Ref: IS/CF001

East City Way Consultation – Phase One

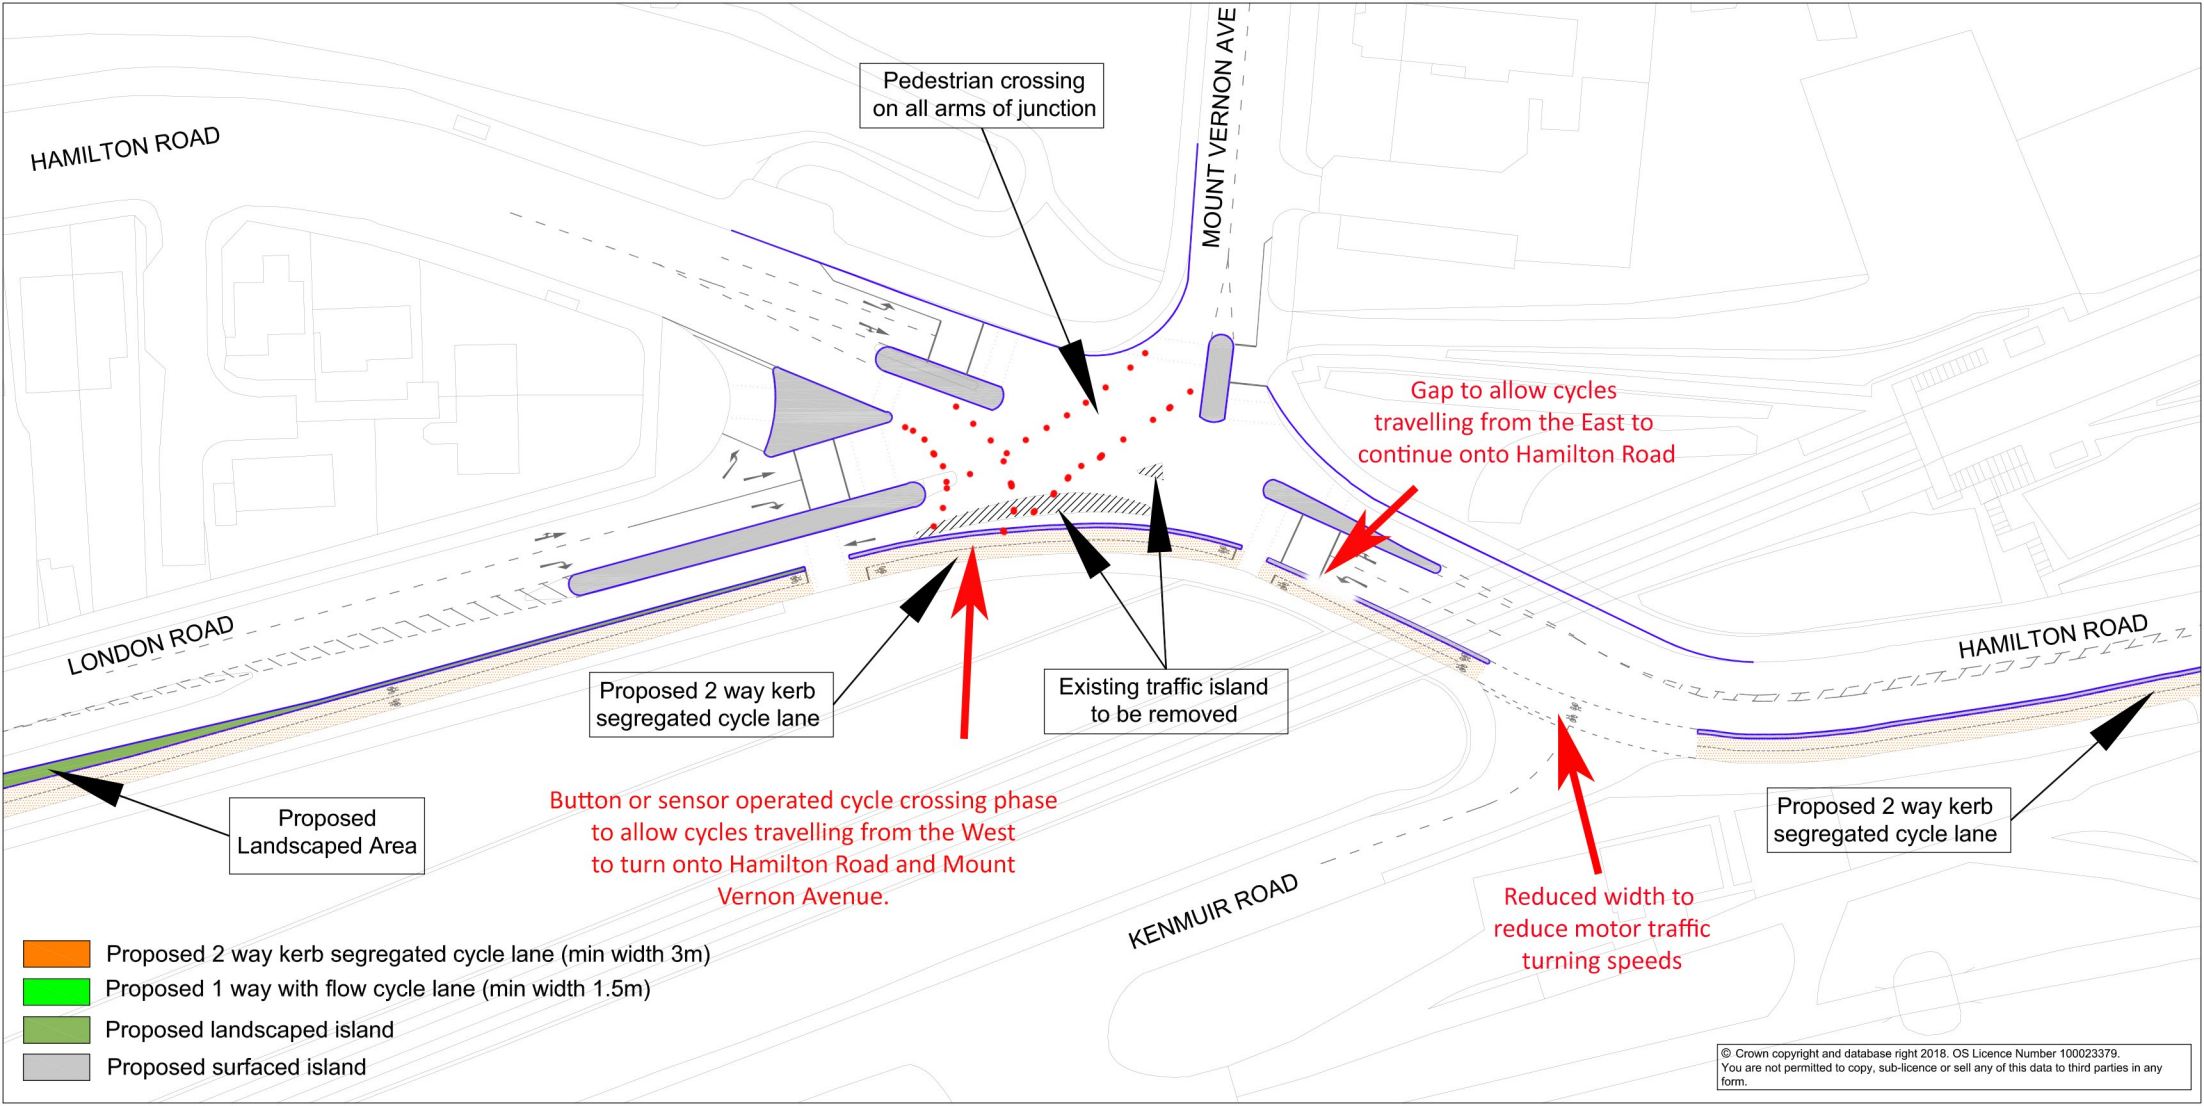
On detailed design, we were a little concerned to see that the junction at Mount Florida had no viable way for cycles travelling from the west to turn onto Hamilton Road or Mount Vernon Avenue, without forcing them to dismount and use pedestrian crossings. Active travel routes need to provide people on bikes with real continuous and efficient options if people are to consider making that modal shift to a form of active transport that they should be able to use continuously from the A to the B of their journey. We would suggest the addition of a crossing along the lines of that on the drawing attached, with a button or sensor operated cycle only crossing phase, taking people on bikes safely to Mount Vernon Avenue and the westerly turn onto Hamilton Road. The council officer I talked to at the drop in session about this crossing, suggested that an additional cycles only crossing phase would be detrimental to the waiting times of the motor traffic at the junction. GoBike dispute that this should be a factor, given that provision for the motor vehicle currently far outweighs any form of active travel, and the transport mode hierarchy outlined within the National Transport Strategy, clearly details that policy in investment needs to prioritise walking and cycling far above the private car (National Transport Strategy (2016) pg.26 Scottish Planning Policy Modal Hierarchy).

A gap at the Hamilton Road crossing also needs to be added to allow for cycles to enter the ASL safely, in order to continue heading west along Hamilton Road. We would also be keen to see the currently very wide entrance to Kenmuir Road narrowed with a sharpened geometry created that would reduce the risk of sweeping turns across the bike lane.

Gap to allow cycles
travelling from the East to
continue onto Hamilton Road

Button or sensor operated cycle crossing phase
to allow cycles travelling from the West
to turn onto Hamilton Road and Mount
Vernon Avenue.

Reduced width to
reduce motor traffic
turning speeds
